**SUBJECT:** NuScale Power, LLC Supplemental Response to NRC Request for Additional Information No. 484 (eRAI No. 8930) on the NuScale Design Certification Application

## **Response to Request for Additional Information Docket No. 52-048**

**eRAI No.:** 8930

**NRC Question No.:** 15-27

**Figure 1-1. Conceptual Boron Transport and Distribution Analysis Results**

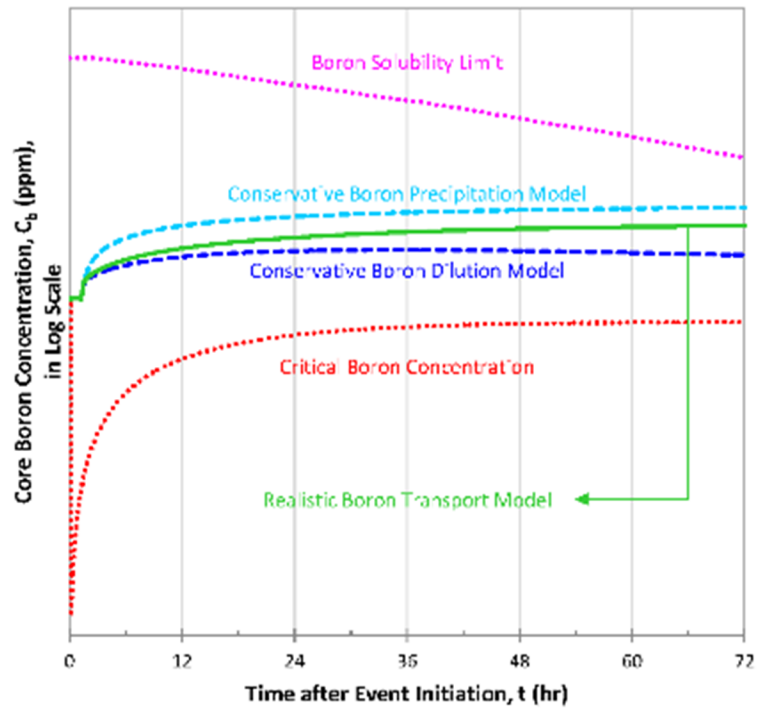
The staff requests the applicant to specify and describe in sufficient detail in the FSAR a methodology used to calculate boron transport during long-term cooling following ECCS actuation after any Chapter 15 event. As part of the description of the methodology, the applicant should appropriately justify the methods, assumptions, and techniques using acceptable validation bases. Furthermore, the staff requests the applicant to provide the results of a long-term cooling analysis that show how a bounding boron dilution event affects the core criticality and coolability. These results should include the quantitative distribution of boron throughout the RCS and containment vessels as a function of time following ECCS actuation. The analysis should consider the most limiting boron dilution volume (e.g. condensate in containment from steaming through the RVVs and from any additional un-borated water already inside containment from breaks in piping carrying un-borated water inside containment). Similarly, the response should include the analysis assumptions and plots of various reactivity effects that determine reactor power to confirm that the core is sub-critical.

precipitation). The purpose and scope of the boron transport and distribution analyses can be represented conceptually as shown in Figure 1-1.

In Figure 1-1, the region bounded between the conservative boron dilution and boron precipitation models (indicated by dashed lines) can be considered as an uncertainty band for the realistic boron transport model (indicated by a solid line). It is likely that the limiting initiating events and conditions are different for the boron dilution and boron precipitation analyses. In the figure, the critical boron concentration and boron solubility limit (indicated by dotted lines) are also included. The boron solubility limit provides the acceptance criteria for boron precipitation analyses. Comparison of the boron dilution analysis result to the critical boron concentration can be used to inform the scope of return to power analyses as discussed further below in Section 1.1.
